Notice of Allowability	Application No.	Applicant(s)	
	09/727,113	RAZZELL, CHARLES JOHN HENDERSON	
	Examiner	Art Unit	
	Juan A. Torres	2631

EXAMINER'S AMENDMENT

1st OA

DETAILED ACTION

FIG. 1 (Prior Art)

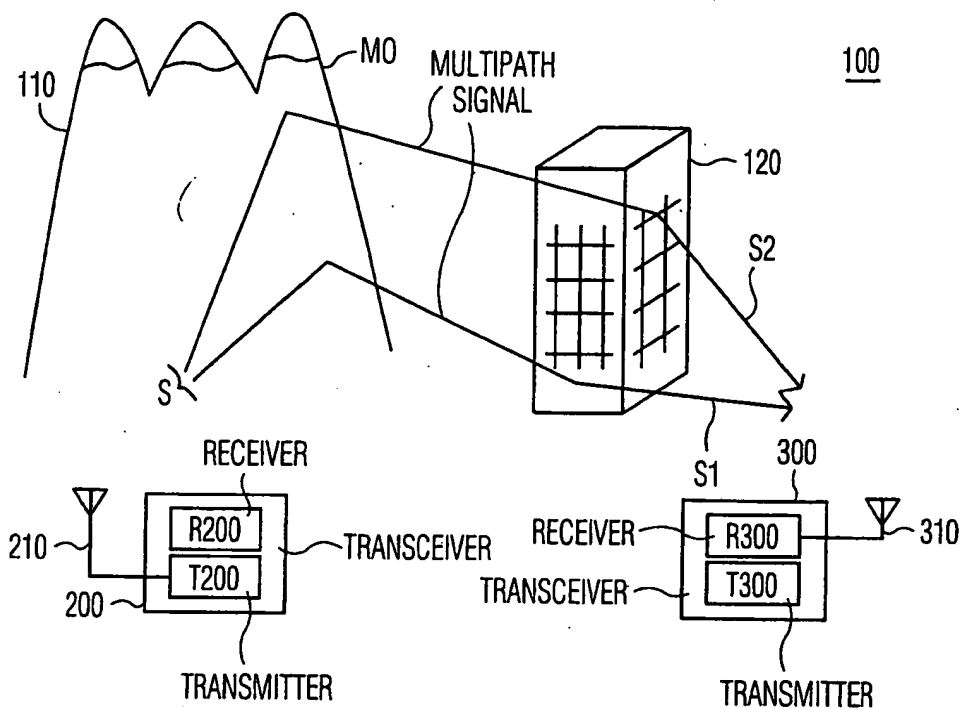
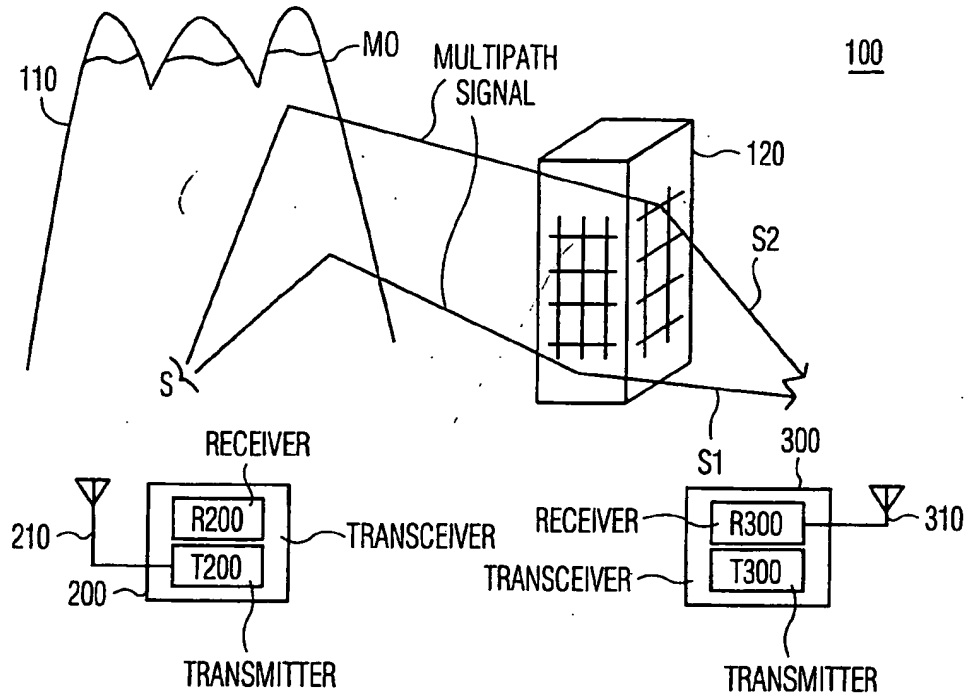
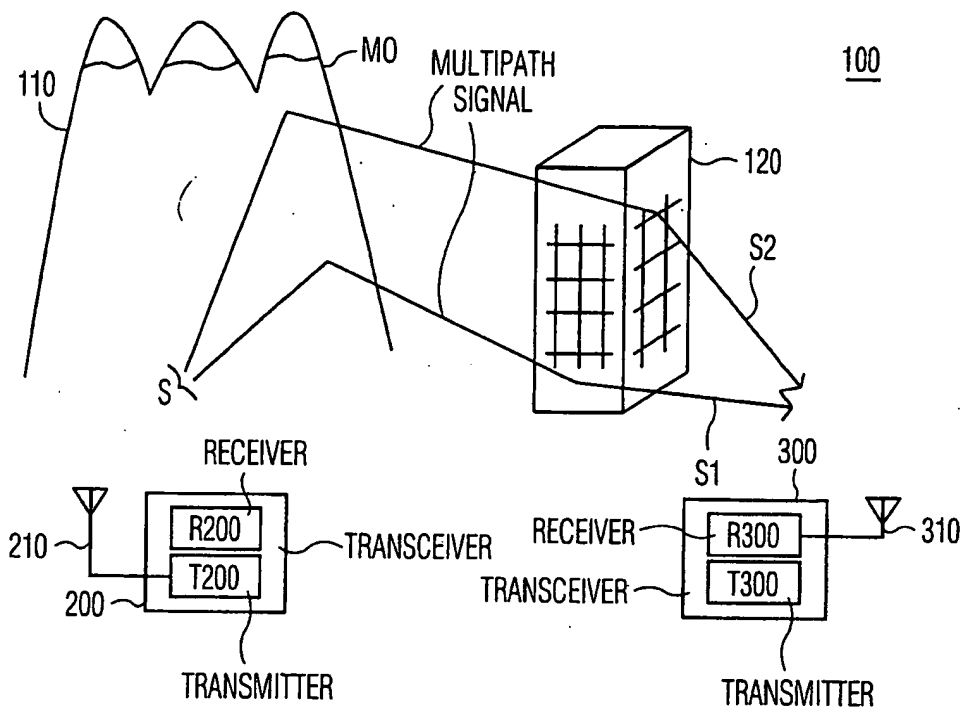
Figures 1-3 should be designated by a legend such as --Prior Art-- because only that which is old is illustrated. See MPEP § 608.02(g). Corrected drawings in compliance with 37 CFR 1.121(d) are required in reply to the Office action to avoid abandonment of the application. The replacement sheet(s) should be labeled "Replacement Sheet" in the page header (as per 37 CFR 1.121(d)) so as not to obstruct

FIG. 2 (Prior Art)

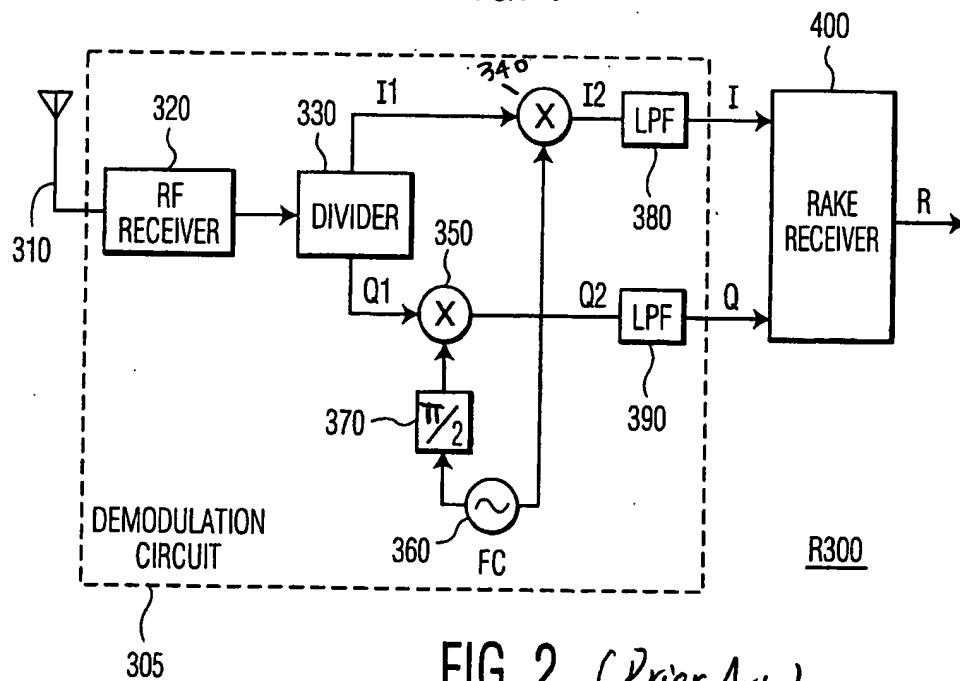
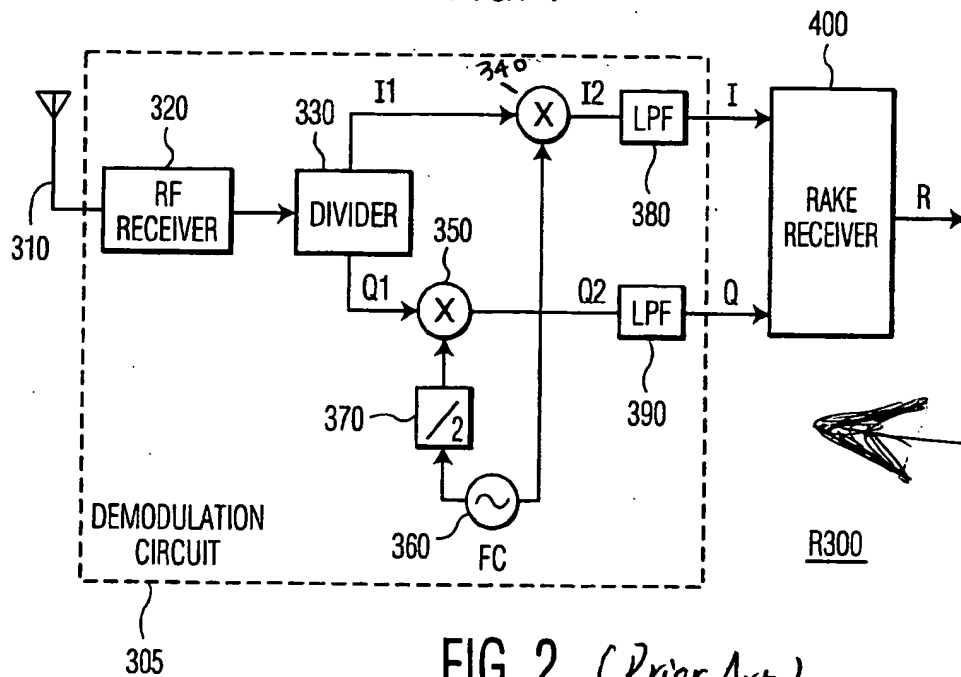
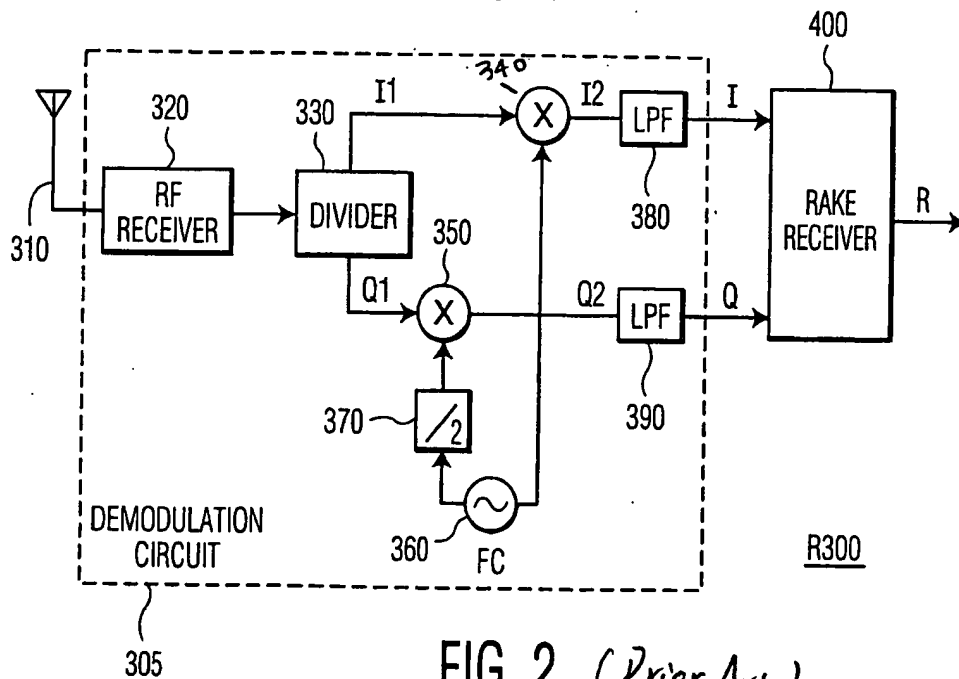
- a) In FIG. 2 block 370 the recitation " $/2$ " is changed to " $\pi/2$ ".
- b) In page 10 line 8 the recitation " $K4^*E > K3^*L$ " is changed to " $K4^*L > K3^*E$ ".
- c) Claim 3 is cancelled.

In FIG. 2 block 370 recites " $T/2$ " it is suggested to be changed to " $\pi/2$ " how it is described in the disclosure in page 7 line 4.

In FIG.2 block 340 as described in page 6 line 32 of the specification.

In page 6 line 11 the recitation "fc" is suggested to be changed to "FC" as indicated in FIG. 2.

In page 6 line 32 the block 340 doesn't shown in the FIG. 2.

The following changes to the drawings have been approved by the examiner and agreed upon by applicant: in FIG. 2 block 370 the recitation " $/2$ " is changed to " $\pi/2$ ". In order to avoid abandonment of the application, applicant must make these above agreed upon drawing changes.

FIG. 3 (prior Art)

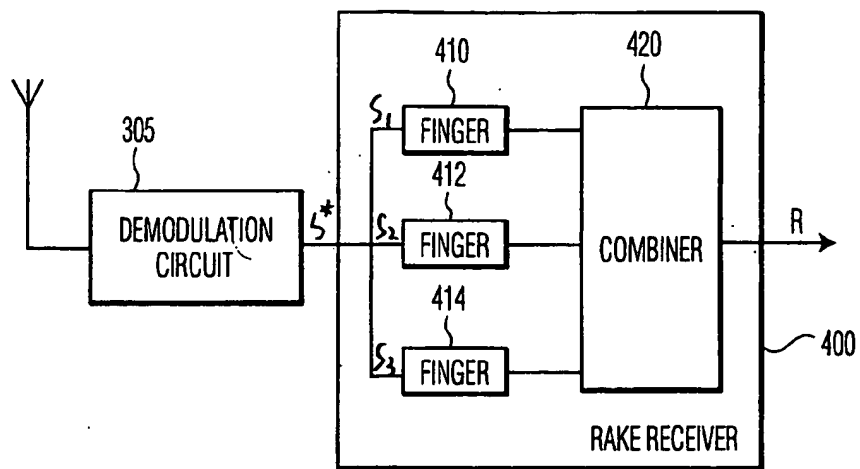
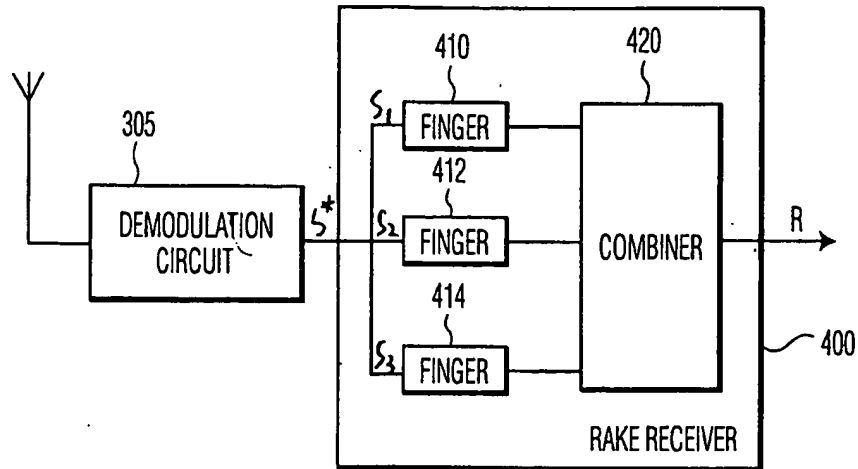
In FIG.3 block S* as described in page 7 line 14 of the specification.

In FIG.3 block S1, S2 and S3 as described in page 7 line 17 of the specification.

In page 7 line 14 the block S* doesn't shown in the FIG. 3.

In page 7 line 17 the block S1, S2 and S3 doesn't shown in the FIG. 3.
